PD Modification Application: PRS 25-0569**Zoning Hearing Master Date:** N/A**BOCC Land Use Meeting Date:** May 13, 2025**Hillsborough
County Florida**

Development Services Department

1.0 APPLICATION SUMMARY**Applicant:** Stonemont Financial Group**FLU Category:** SMU-6**Service Area:** Urban**Site Acreage:** 14.51**Community
Plan Area:** Town N' Country**Overlay:** None**Introduction Summary:**

2.3 Approved Site Plan (partial provided below for size and orientation purposes. See Section 8.1 for full site plan)

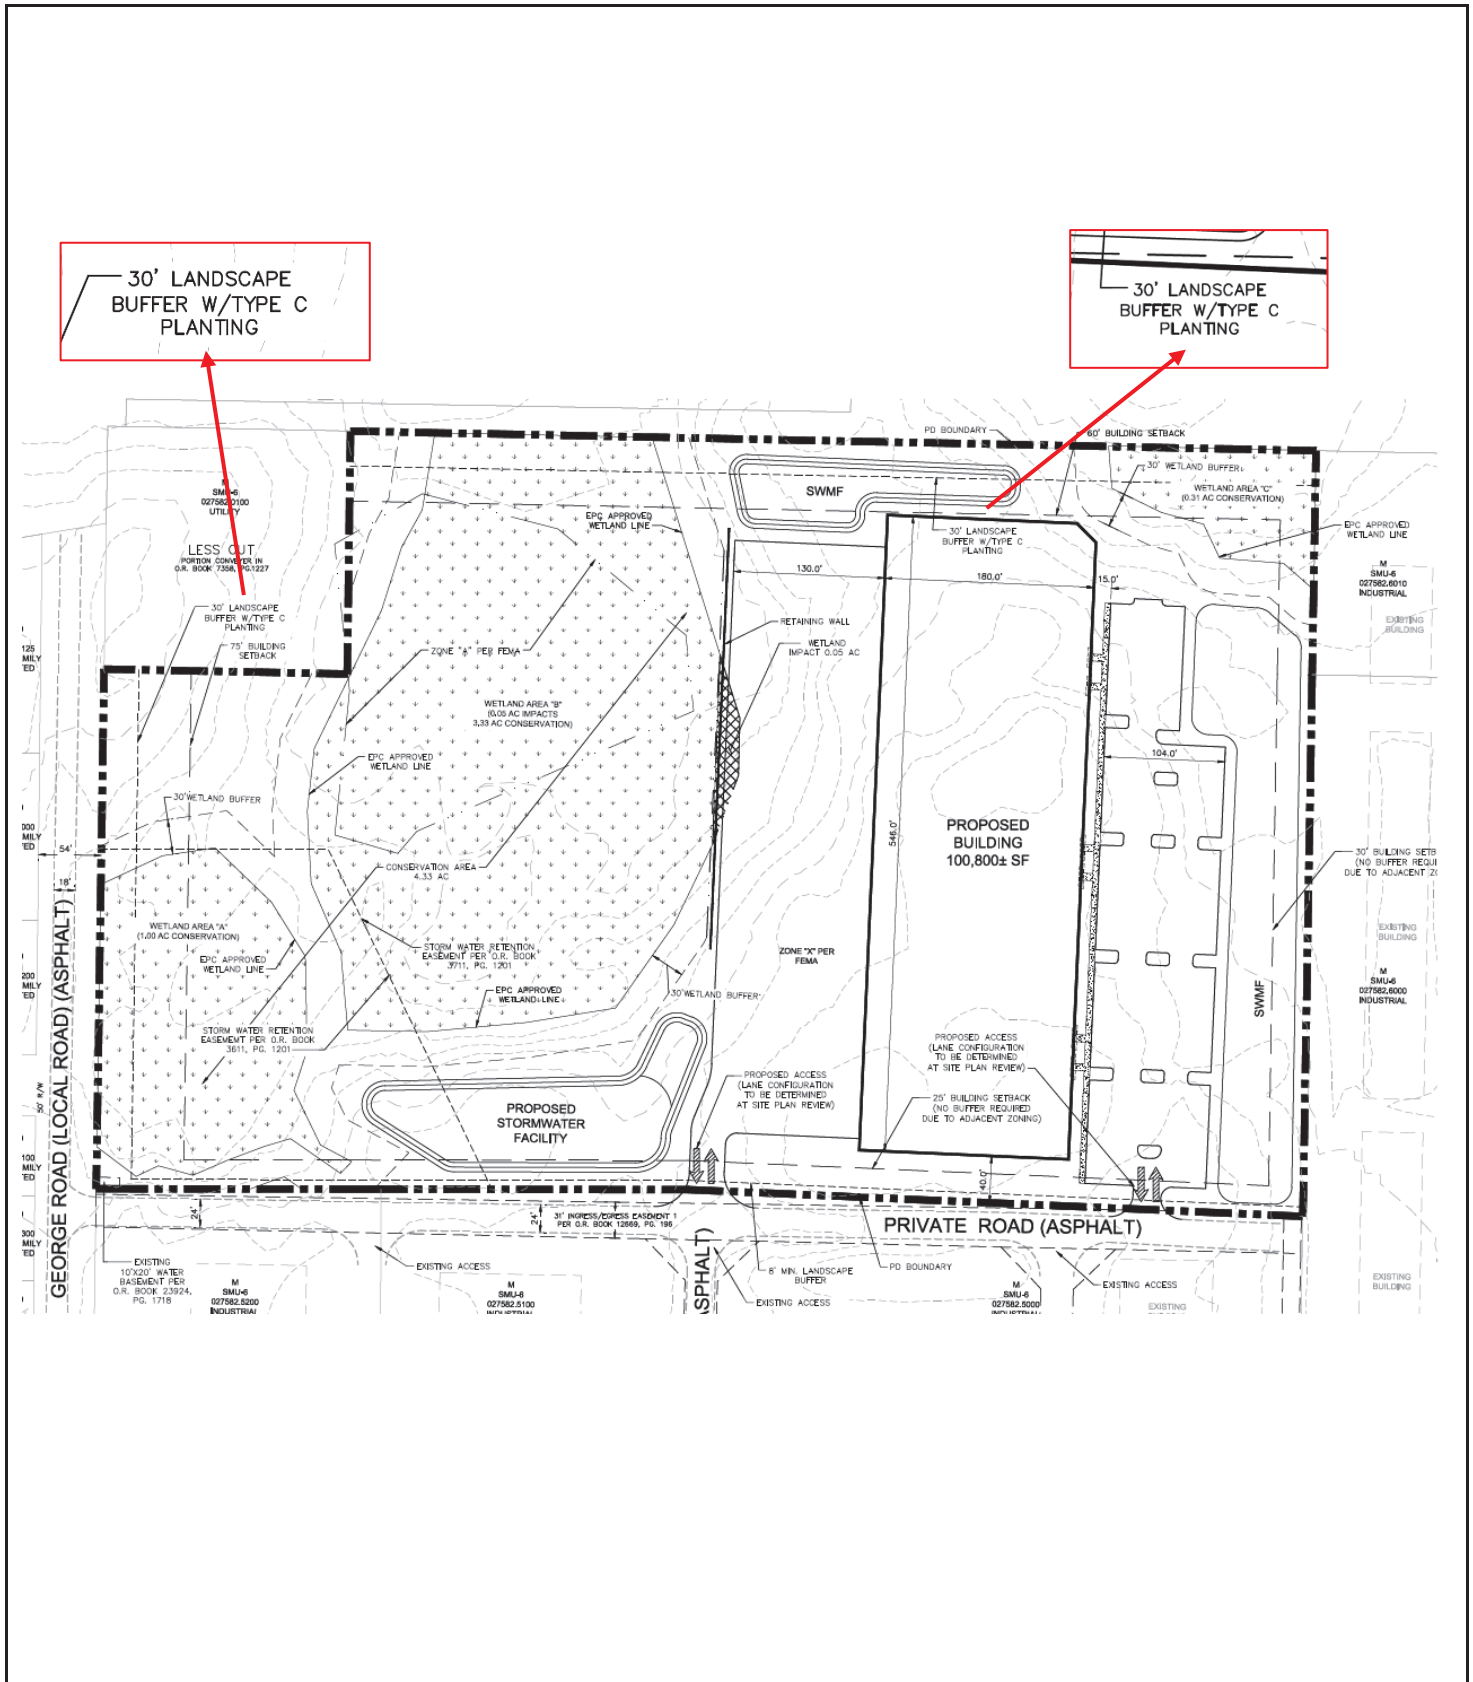
Applicant looks to modify the site plan of Planned Development 18-1163 (recently modified by 21-0556) in order to alter the screening requirements along the northern and western boundaries, specifically removing the requirement to construct a masonry wall. No use, setback, building height, or square footage change is proposed.

The site plan depicts the proposed building, to be utilized for warehouse and distribution, located along the eastside of the property. The building is separated from the west boundary by a 4.33 acre wetland area. With the building being setback significantly from the west towards the residential development, we have no issues with the screening changes. Development will still be required to maintain a 30' buffer and provide plantings required for Type C screening. The north property screening will also be required to maintain a 30' buffer and provide Type C plantings. There is no residential to the north and the greenway trail is separated by the existing agricultural use and natural vegetation on the property.

3. The landscape buffering and screening shall be in accordance with the requirements of Part 6.06.00 of the Land Development Code, except as provided herein. The developer shall provide a 30-foot buffer and Type C plantings, but no masonry wall, along the western and northern boundaries (as depicted on the General Site Development Plan).

2.4 Proposed Site Plan (partial provided below for size and orientation purposes. See Section 8.2 for full site plan)

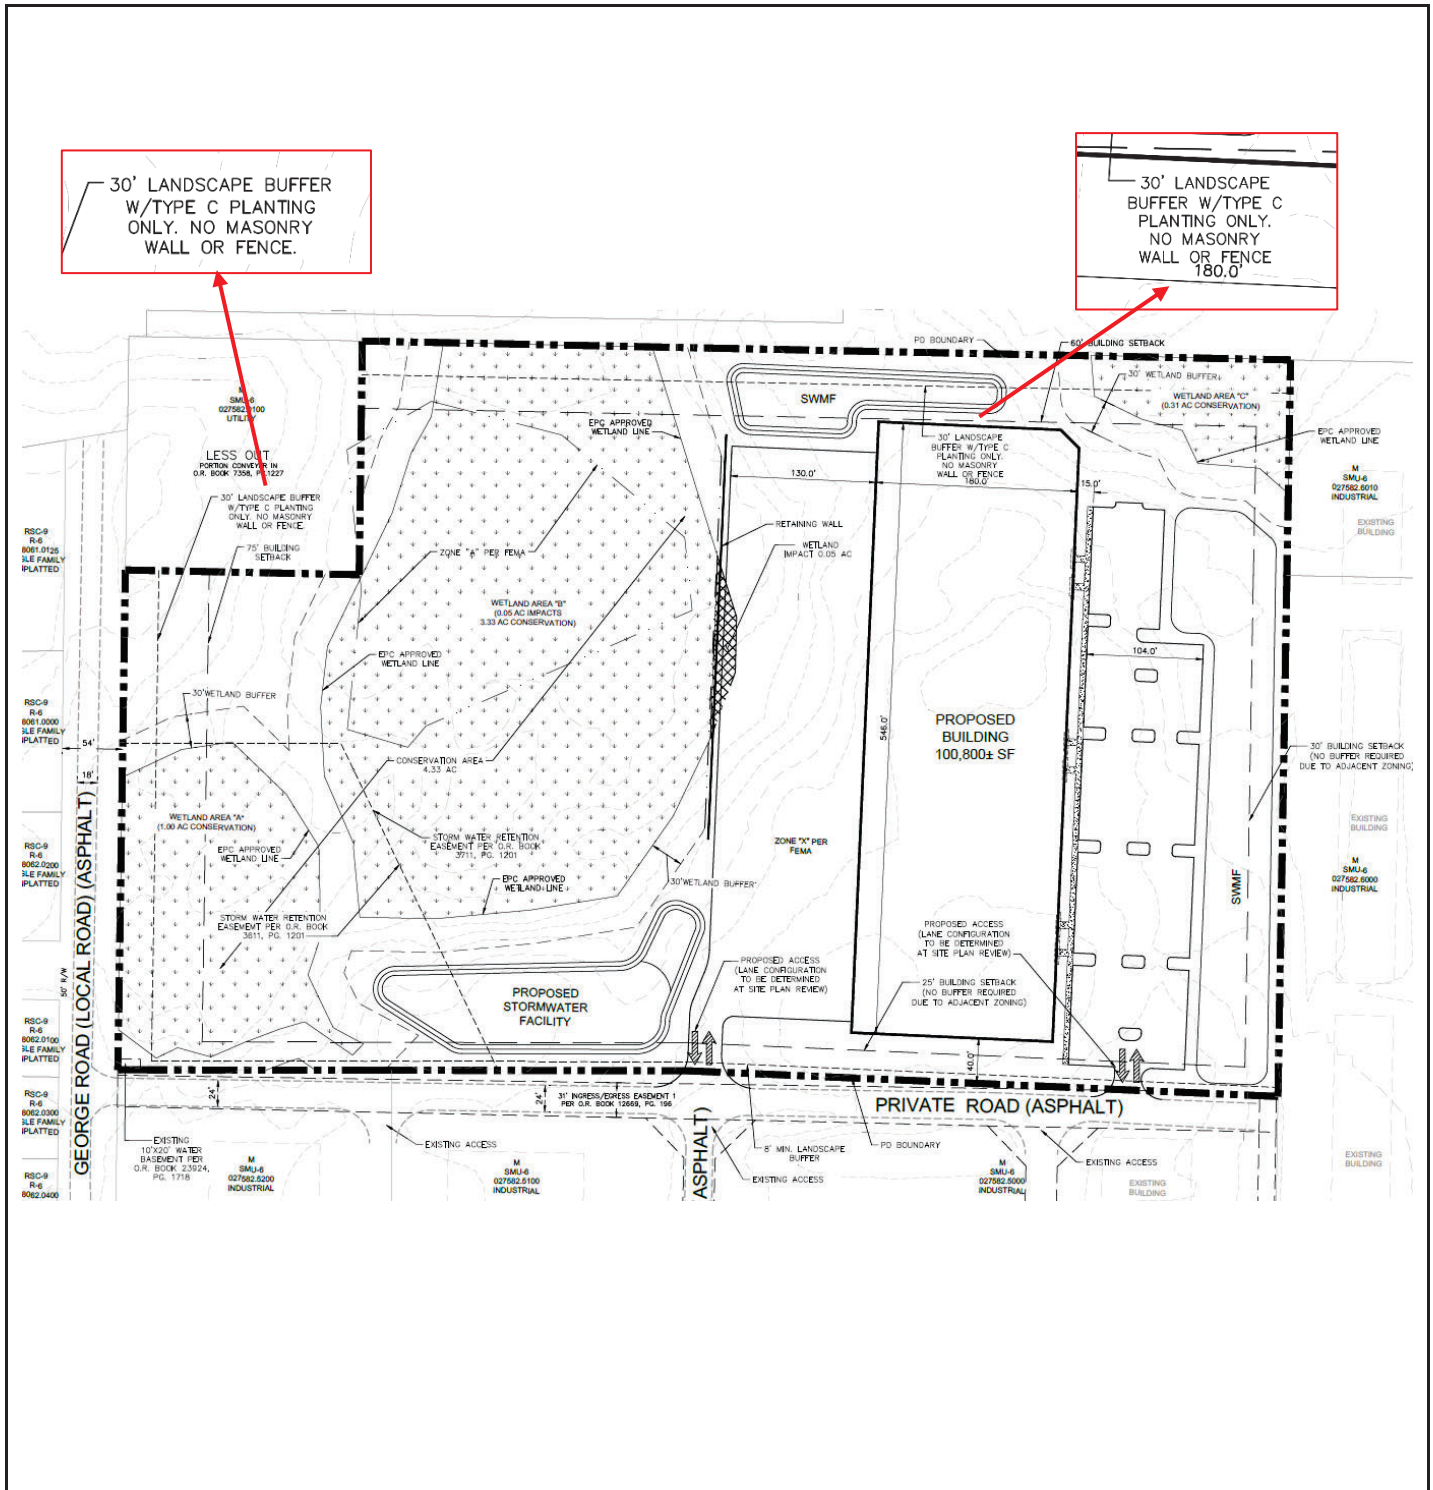
1. The developer shall amend the label of the internal drive which is currently labeled "Private Road" to "Private Drive" shown on Page 1 of 1 of the site plan.
2. The developer shall remove the roadway measurements and apron detail connecting to George Road shown on Page 1 of 1 of the site plan.
3. The developer shall include directional arrows for each point of access onto Johns Road.

8.1 Approved Site Plan (Full)

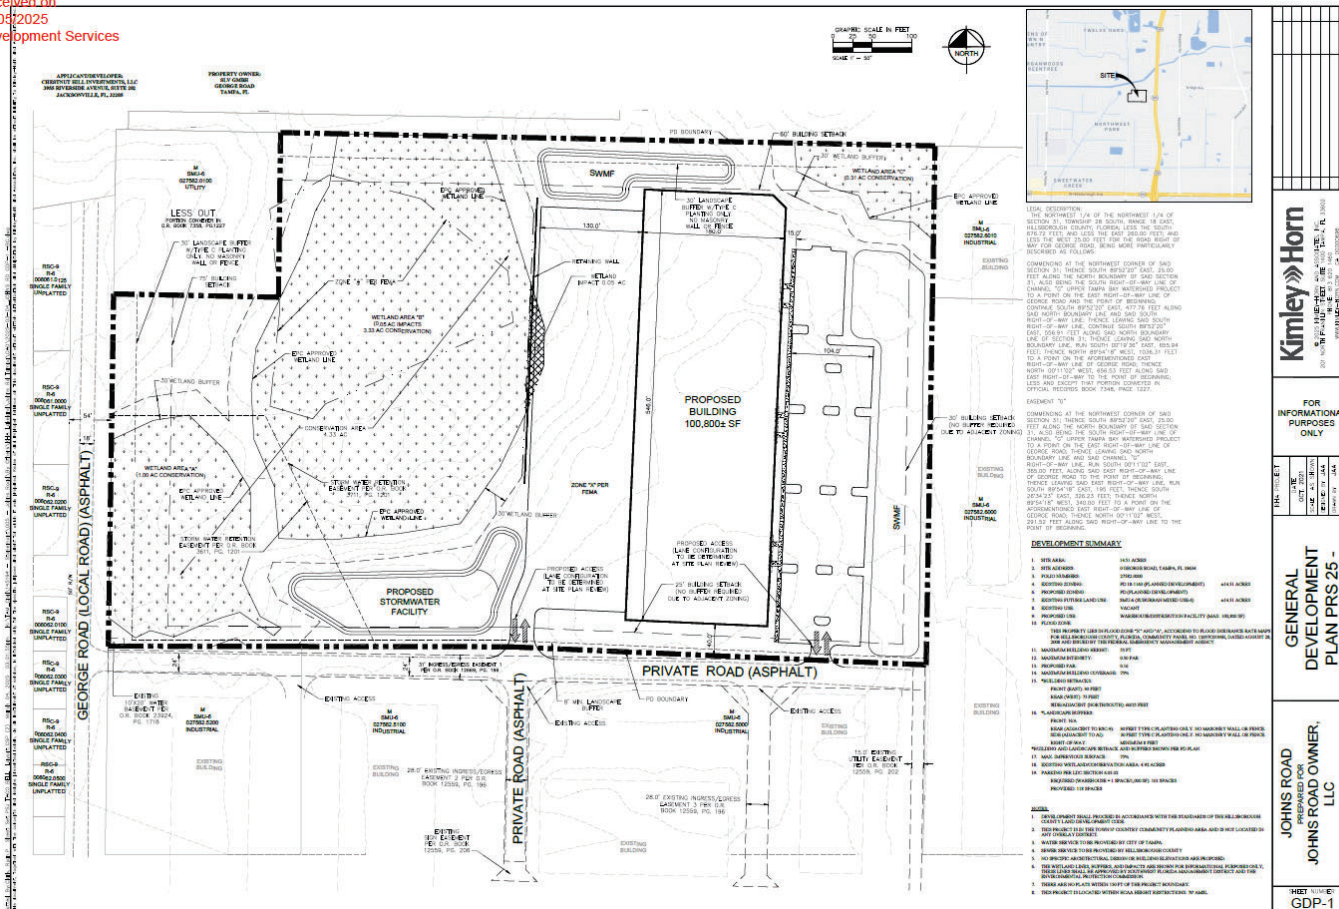
- The developer shall amend the label of the internal drive which is currently labeled "Private Road" to "Private Drive" shown on Page 1 of 1 of the site plan.
- The developer shall remove the roadway measurements and apron detail connecting to George Road shown on Page 1 of 1 of the site plan.
- The developer shall include directional arrows for each point of access onto Johns Road.
